**CHILLED WATER PIPING REVISION
 CORRECT MECHANICAL
 DEFICIENCIES BUILDING 26
 589A7-16-101
 1-18-2017**

PIPE CURB DETAIL

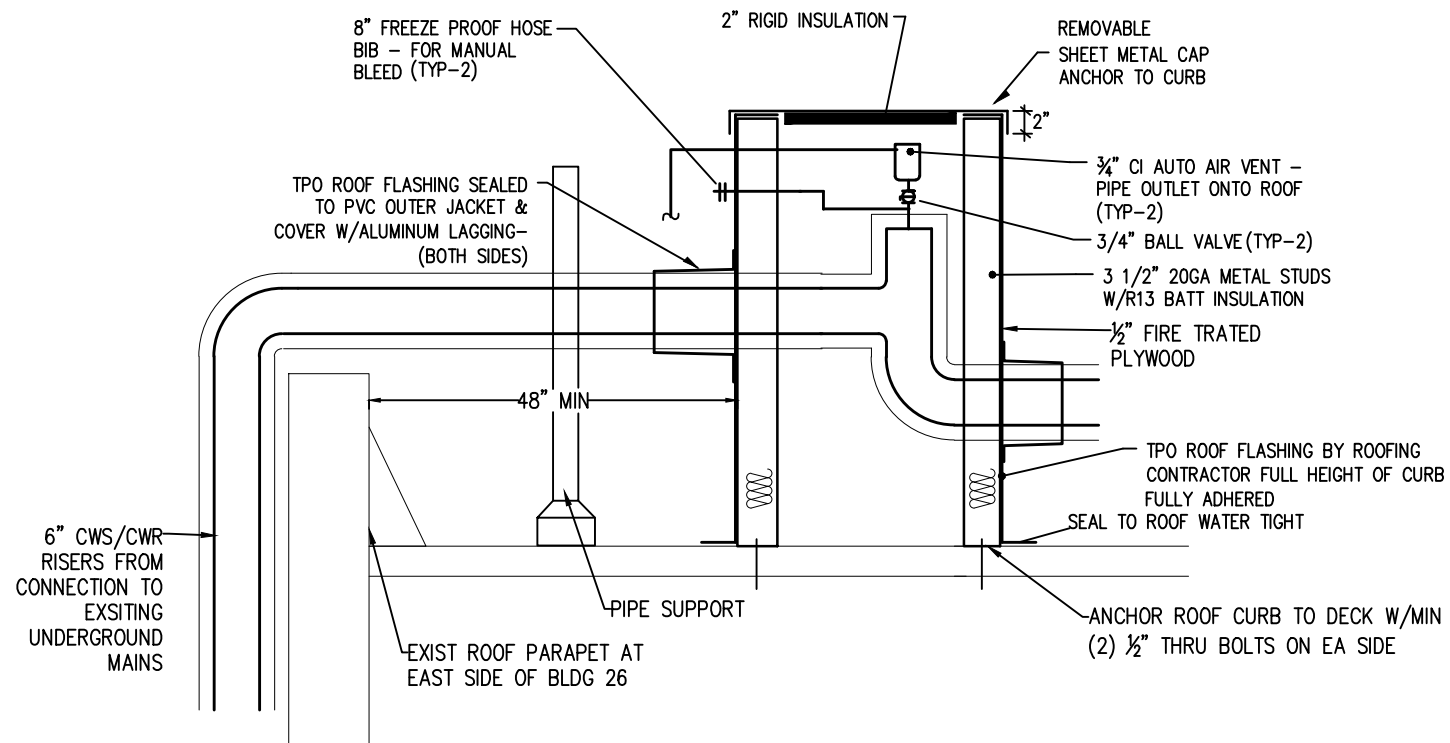
- AIR REMOVAL FITTINGS REQ'd FOR BOTH LINES
- INSULATE ALL CHILLED WATER COMPONENTS VAPOR TIGHT
